CSMP – Field Advisory Notice (FAN)

SAFE Sens TrakPod Electro Magnetic Interference (EMI)

050218POD0014

Figure 1: TrakPod Electro-Magnetic Interference (EMI) - Example

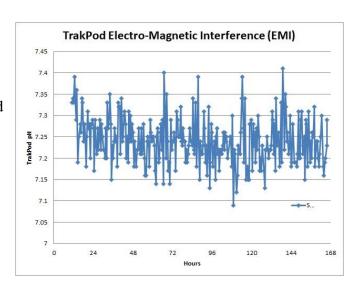
Multiple sites reported "variability" in TrakPod readings during routine pH monitoring. The behavior presented as rapid fluctuations in pH readings, and was not typical or expected of pH measurements taken with the SAFE Sens system.

The pH monitoring data from the affected customer sites showed the TrakPod's fluorescent signals varying from reading to reading, in some case by significant counts. The behavior appeared situational, seemed specific to the TrakPod when placed in a certain condition, and could not always be replicated upon examination. Further investigation found that sufficiently-powerful localized Electro-Magnetic Interference (EMI) may influence the behavior of the current TrakPod design. EMI causes variability in TrakPod measurements, manifesting as noisy pH data. See Figure 1.

Service Plan instructions and materials for impacted users are provided by BCSI. Please contact our support team at support@safesens.com for more information on servicing this issue.
